DIXIE-NARCO

Service Bulletin # 197

MODELS: All Serpentine

SUBJECT: Jackpotting Cans - Rimless

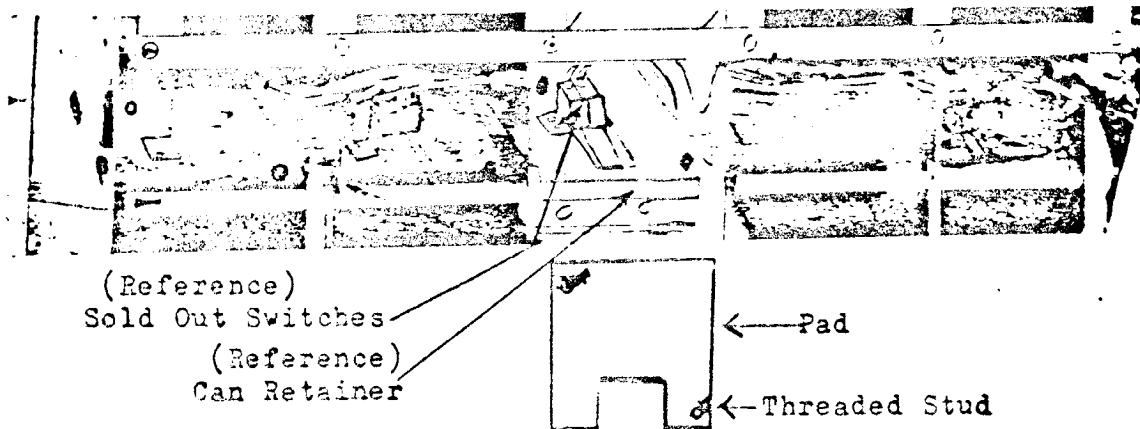
REASON: To provide an Anti-Jackpot Pad to prevent jackpotting.

- DO THIS:
1. Install "Pad" in position shown, on the underside of the Can Retainer.
 2. The "Pad" has two (2) threaded studs. Align the studs with the existing holes in the Can Retainer.
 3. Secure with nuts and washers.
